RE – Yass Valley Wind Farm Preferred Project Report response (our ref. 4743)

Thank you for providing the OEH comments regarding this project, addressed to Department of Planning and Infrastructure, dated 29 August 2013.

ISSUES AND APPROACH OVERVIEW

1 CLARIFICATION OF ISSUES / DISCREPANCIES RAISED IN OEH SUBMISSION

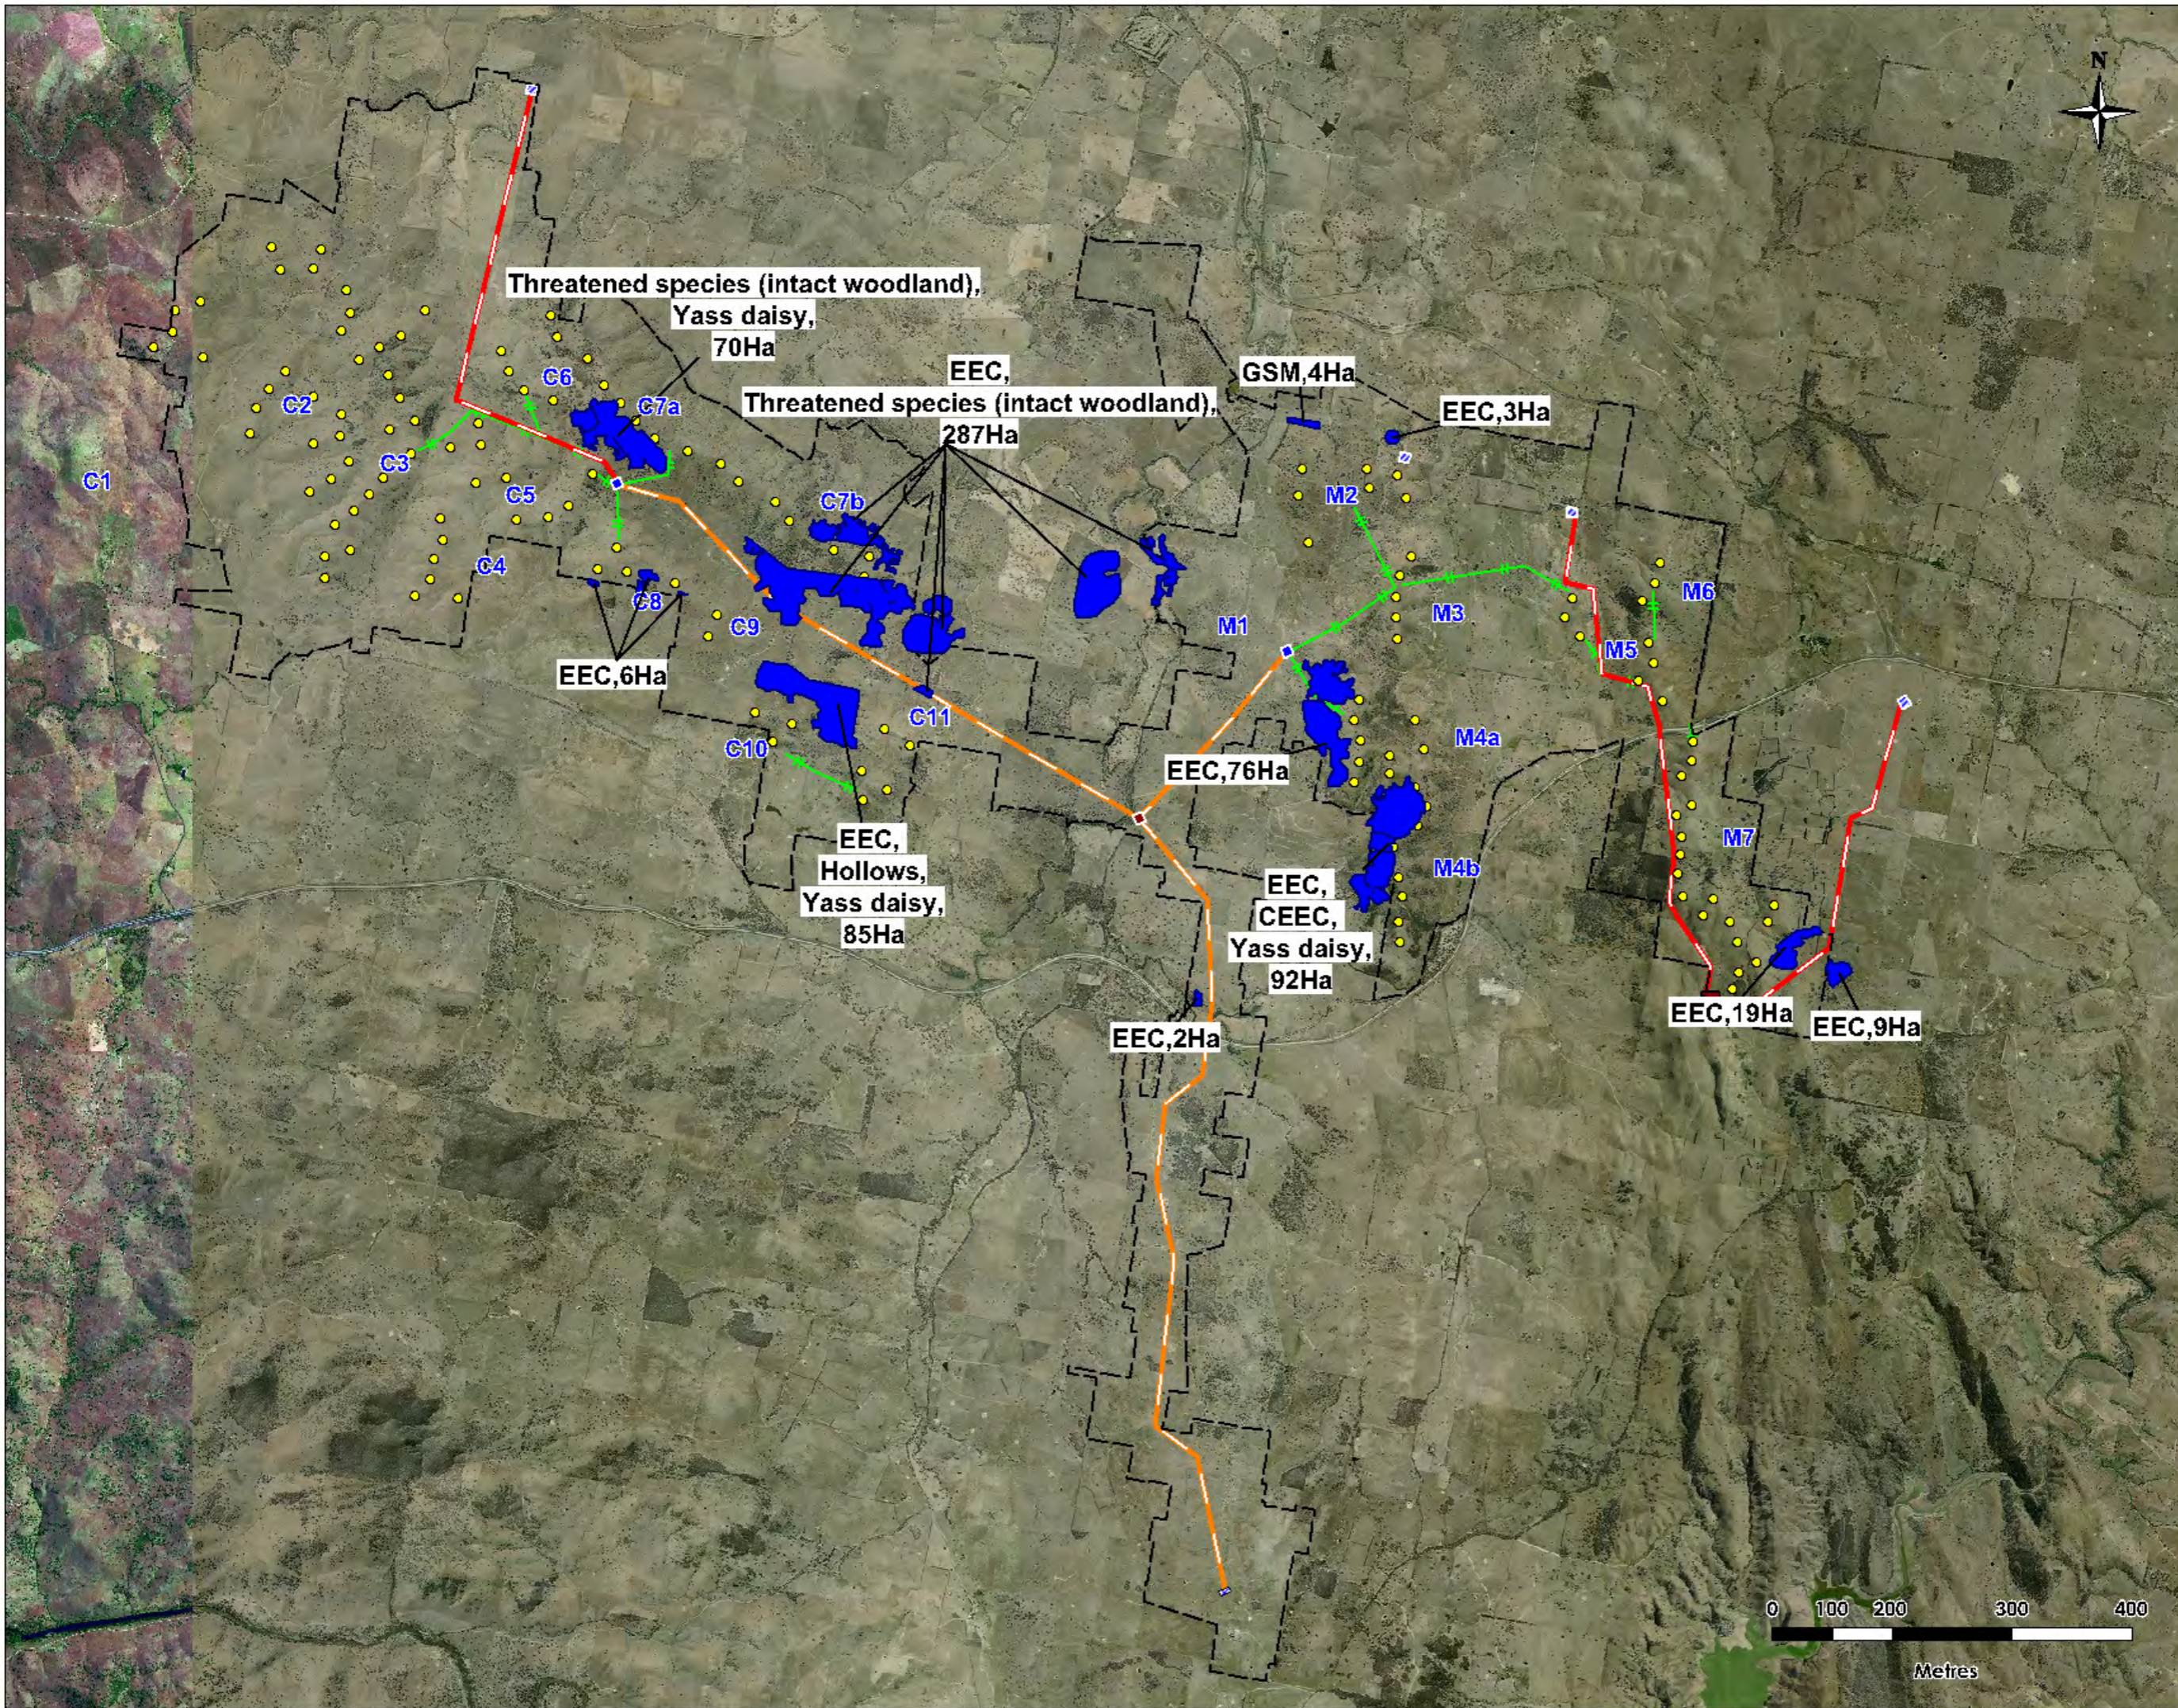
Some of the larger and more connected areas cited above have been mapped to indicate a potential offset package. The total area mapped totals around 650 ha. Without breaking down the specific offset requirements, this generally achieves a 1: 3 ha offset. On this basis, the security of offsets for the project is considered to be highly feasible.
